RE: INTERIM AUDIT ADVICE LETTER NO. 2 - REVIEW OF RAP ADDENDUM, SYDNEY MODERN

As a NSW Environment Protection Authority (EPA) accredited Contaminated Sites Auditor, I am conducting an Audit in relation to the Art Gallery of NSW Expansion - Sydney Modern Project building located at Art Gallery Road, The Domain, Sydney.

Conditions identified during recent construction works have necessitated changes to the remedial strategy proposed in the RAP. Coffey prepared 'Remediation Action Plan - Addendum 1, Sydney Modern Development, Art Gallery Road, Sydney NSW' (the RAP Addendum) dated 5 May 2020 to document an alternate remediation strategy for the site.

client:	RICHARD CROOKES CONSTRUCTIONS		
project:	ENVIRONMENTAL MANAGEMENT PLAN SYDNEY MODERN PROJECT WOOLLOOMOOLOO, NSW		
title:	SITE LAYOUT PLAN		
project no:	754-SYDGE234348	figure no:	FIGURE 1
rev:	B

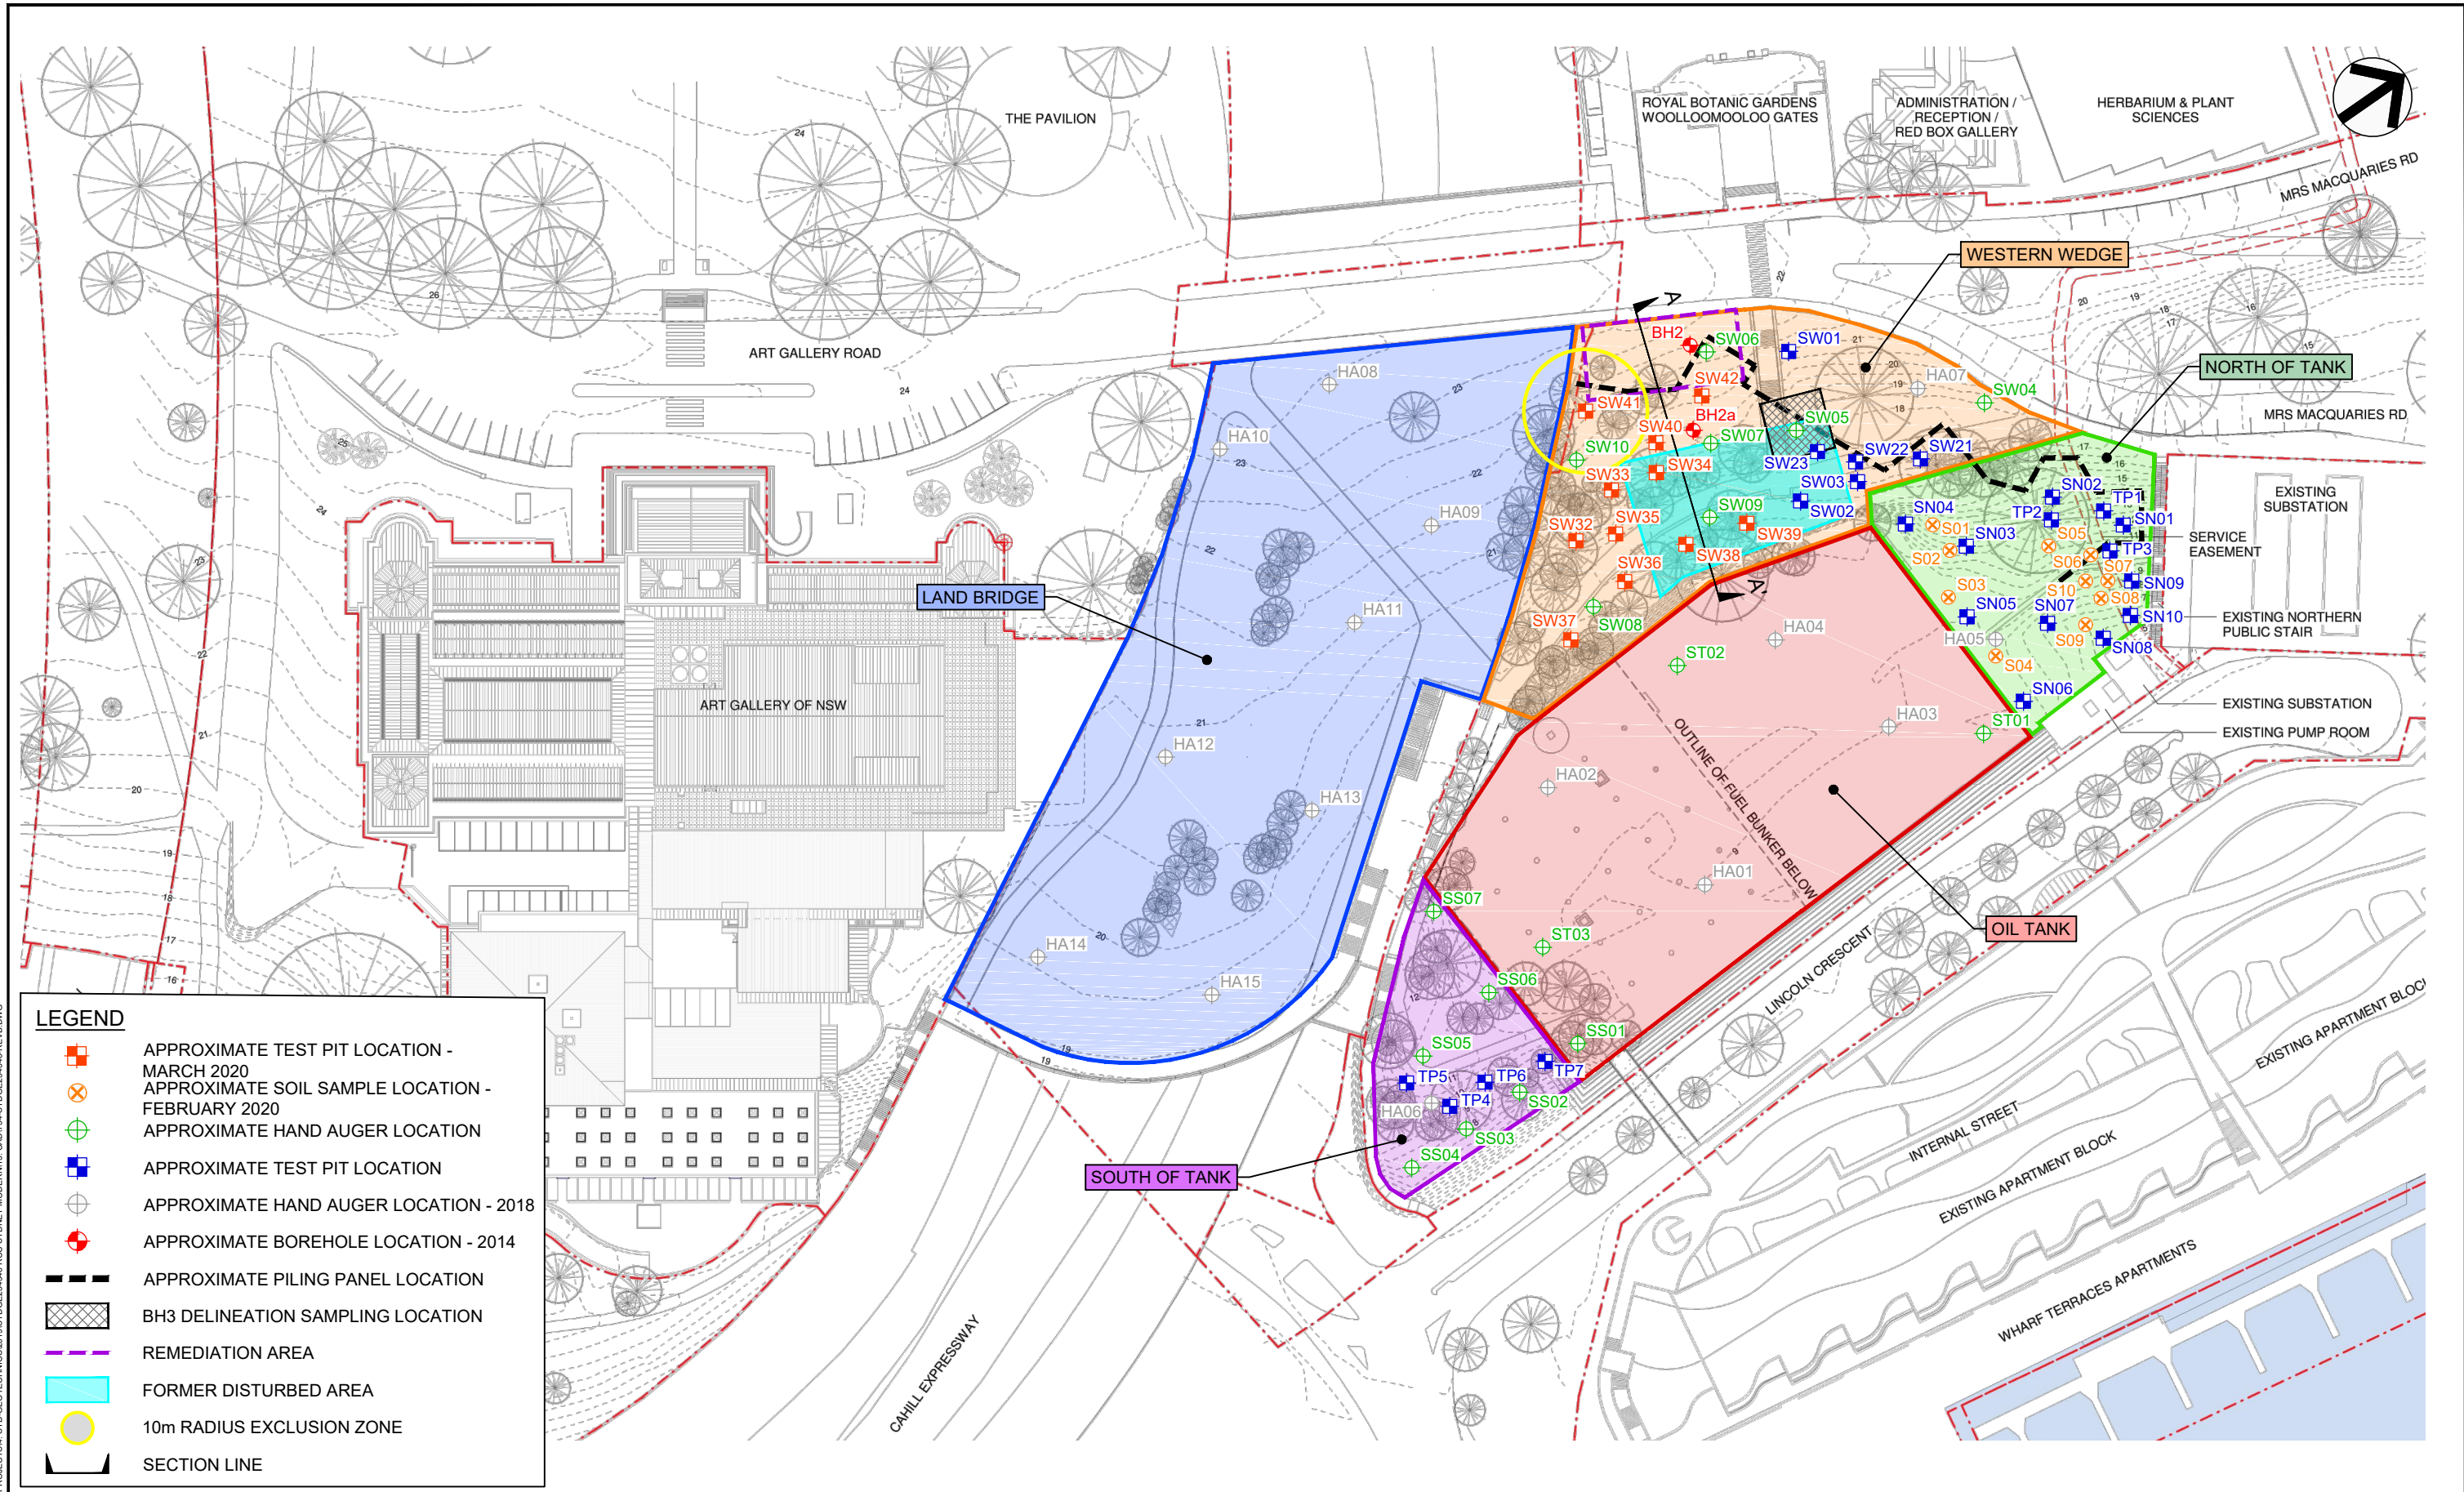
- Remediation of areas for building construction to continue in accordance with the current RAP, i.e. excavation and offsite disposal of fill material located to the east of the pile wall in the North of Tank and Western Wedge areas (east of the black dashed line on Attachment 1).
- Landscaped areas to the west of the pile wall (west of the black dashed line on Attachment 1) are unable to be remediated in accordance with

client:	RICHARD CROOKES CONSTRUCTIONS		
project:	SYDNEY MODERN PROJECT WOOLLOOMOOLOO, NSW		
title:	COVER LAYER - WESTERN WEDGE AREA		
project no:	754-SYDGE234348-EH	figure no:	FIGURE 2
rev:	A

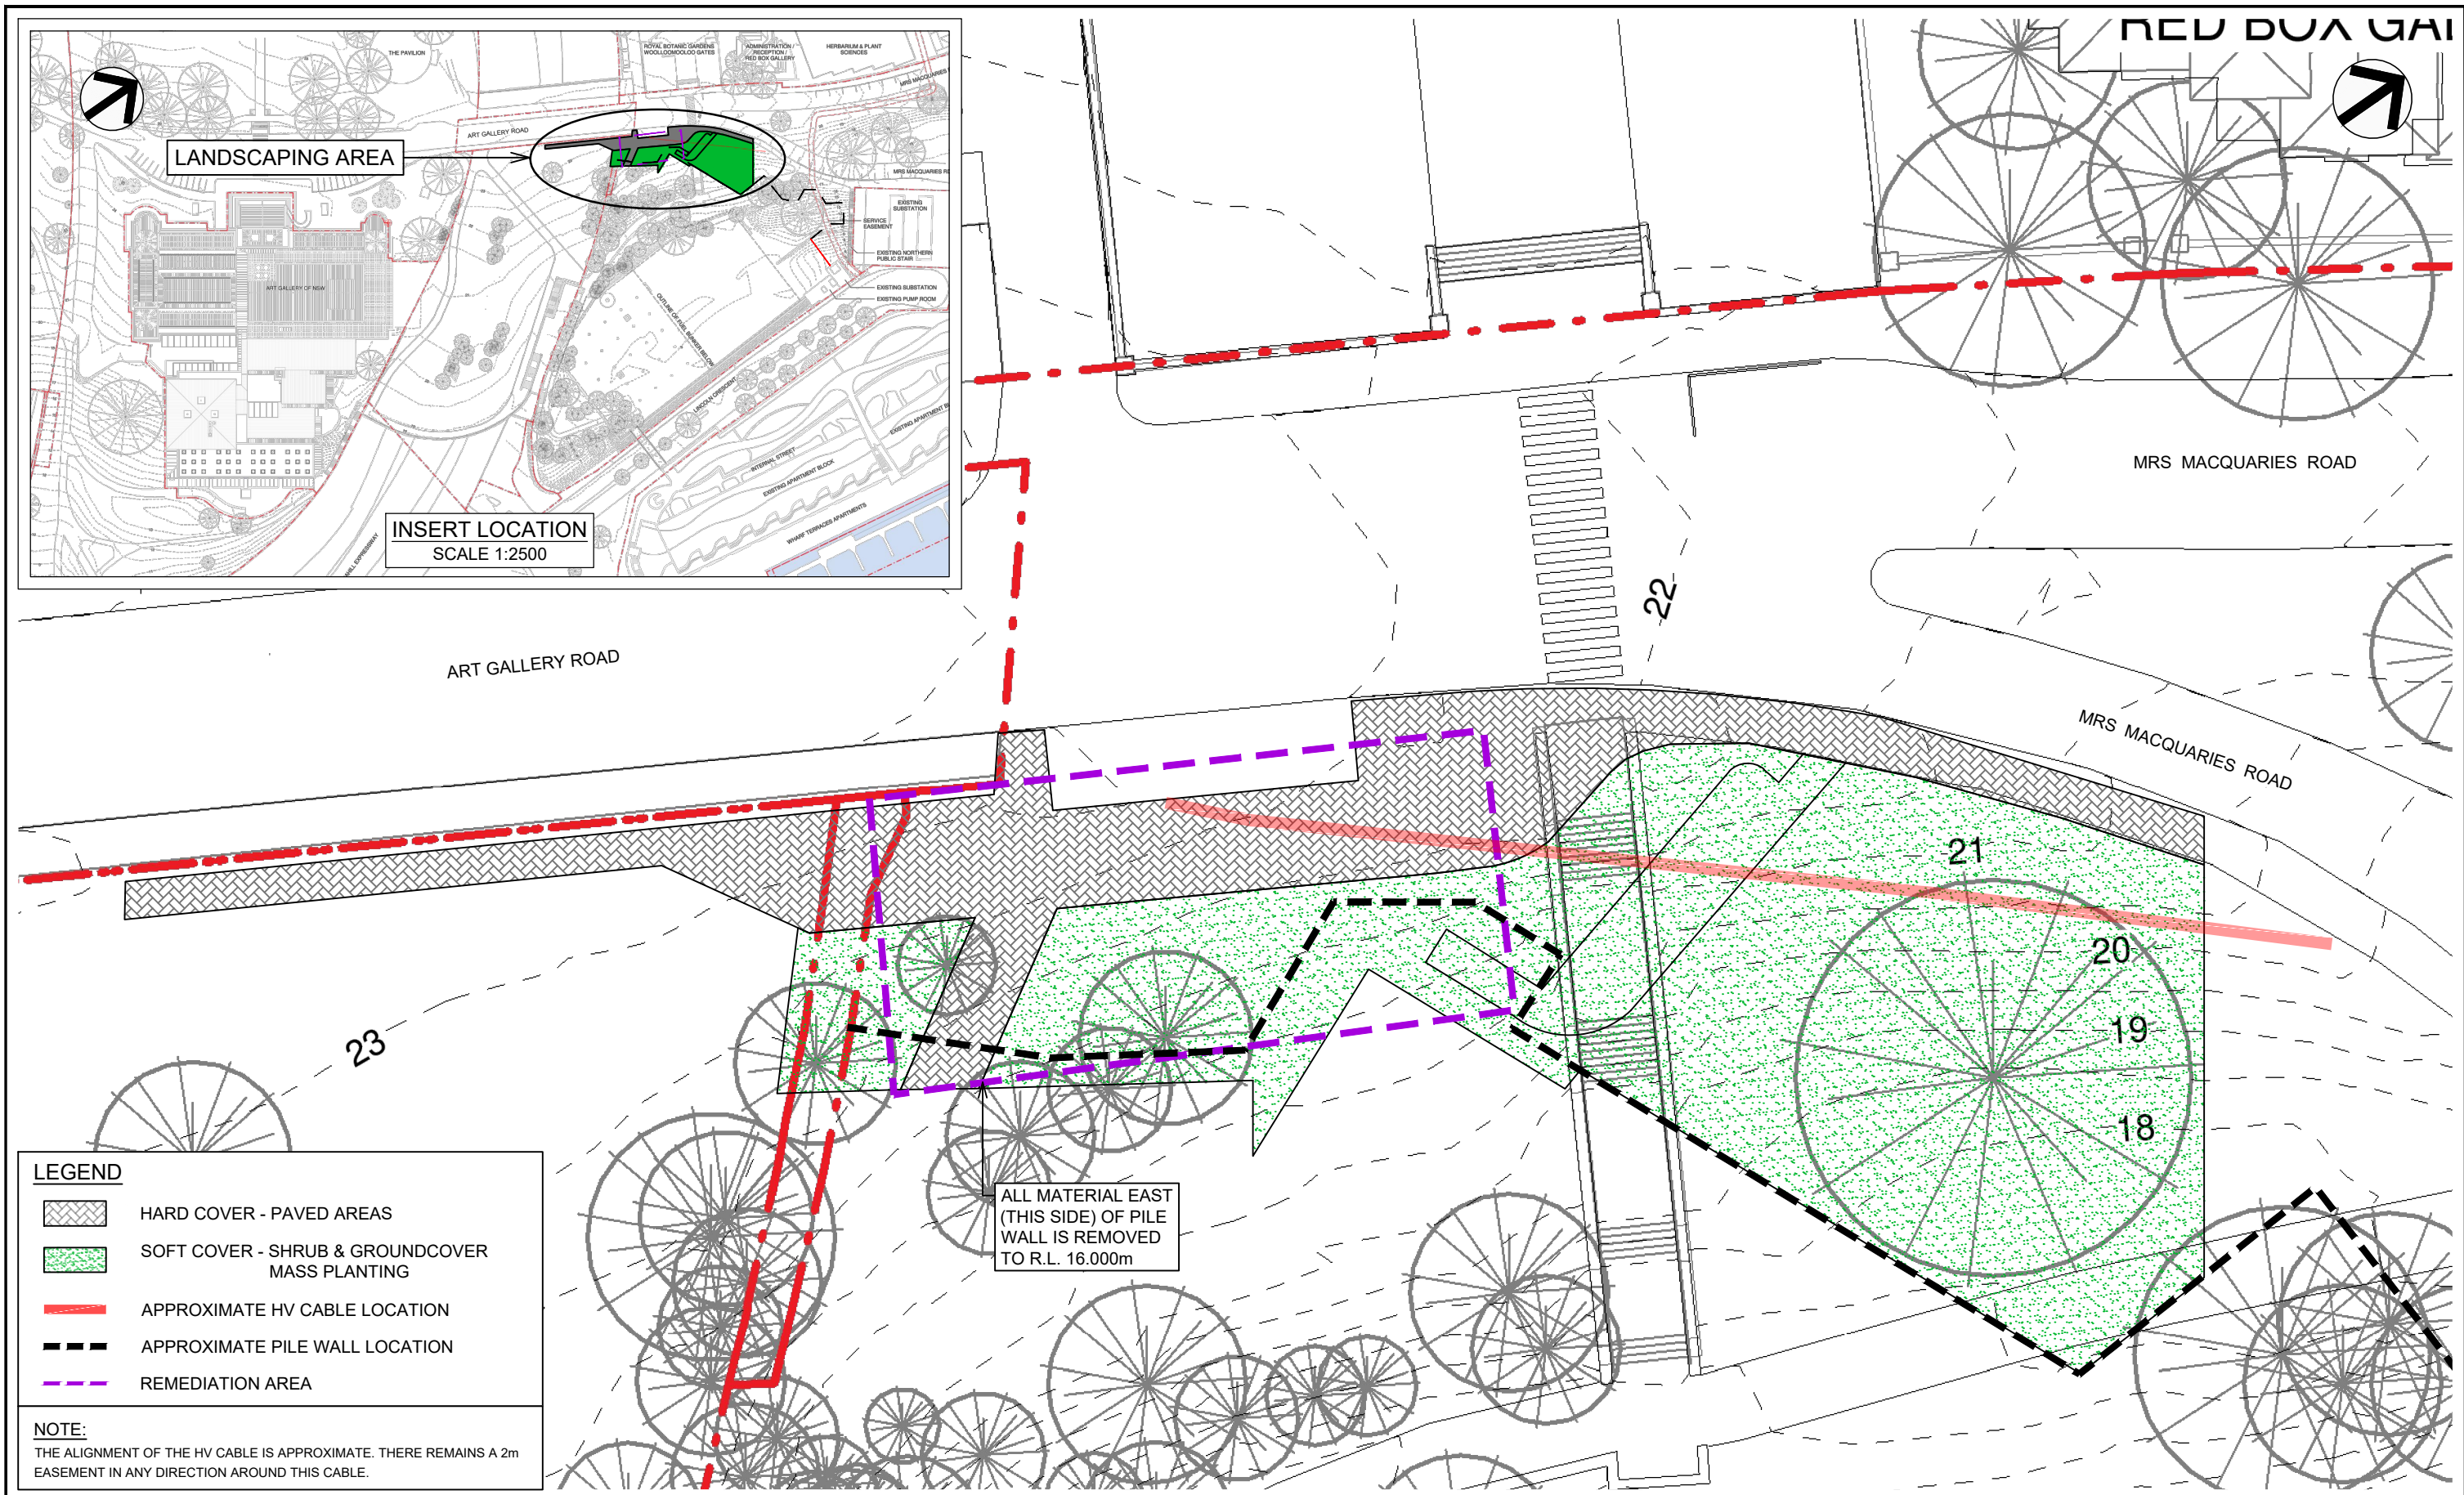
3. The lateral extent of the capping layer in the Western Wedge does not cover the entire area west of the pile wall (Attachment 2). Limited information has been provided to date to justify exclusion of the capping layer in this area. The extent of the capped area in the Western Wedge will need to be justified in the validation report.
